**DUKE STREET/LARCHFIELD STREET**

**ROAD SAFETY ASSESSMENT REPORT**

## Duke Street/Larchfield Street

## Road Safety Assessment

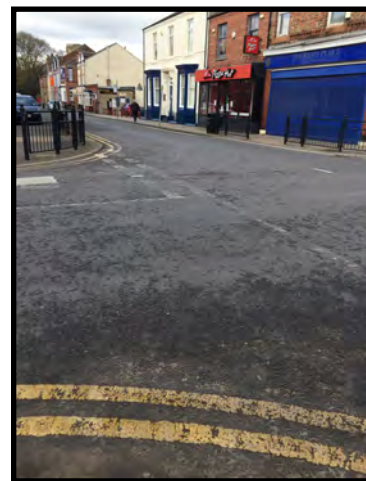
During the day site visit drivers were observed parking illegally on the “no waiting at any time” restrictions on the north east side of the junction. The majority appeared to be visiting the hair salon and were parked for the full length of the site visit.

During the night site visit drivers were parked along the majority of the north side of Duke Street, predominantly on the single yellow line (restrictions 8am to 6pm), a small number were parked illegally on the “no waiting at any time” restrictions.

The parking on the north side of Duke Street could result in the following issues:

- Inadequate inter-visibility between road users on Duke Street and road users exiting Larchfield Street (southbound).
- Insufficient width to allow two way movements on Duke Street and limited passing opportunities which may result in an increase in vehicles reversing.

- 4.1 Introduction of “no loading at any time” restrictions on the north side of Duke Street at the junction of Larchfield Street to ensure minimum inter-visibility of 43m (Manual for Streets) is maintained between road users on major and minor arms of the junction.
- 4.2 Extension of the guard rail on the north side of Duke Street to reinforce the “no loading at any time” restrictions.
- 4.3 Provide adequate opportunities on the north side of Duke Street to allow two way traffic to pass after 6pm and vehicles can legally park on the north side of Duke Street.
- 4.4 Refresh the road markings at the junction and provide yellow backing boards for the “give way” signage on both Larchfield Street approaches.
- 4.5 Provide additional traffic calming measure on both Larchfield Street approaches to reinforce the table top junction.
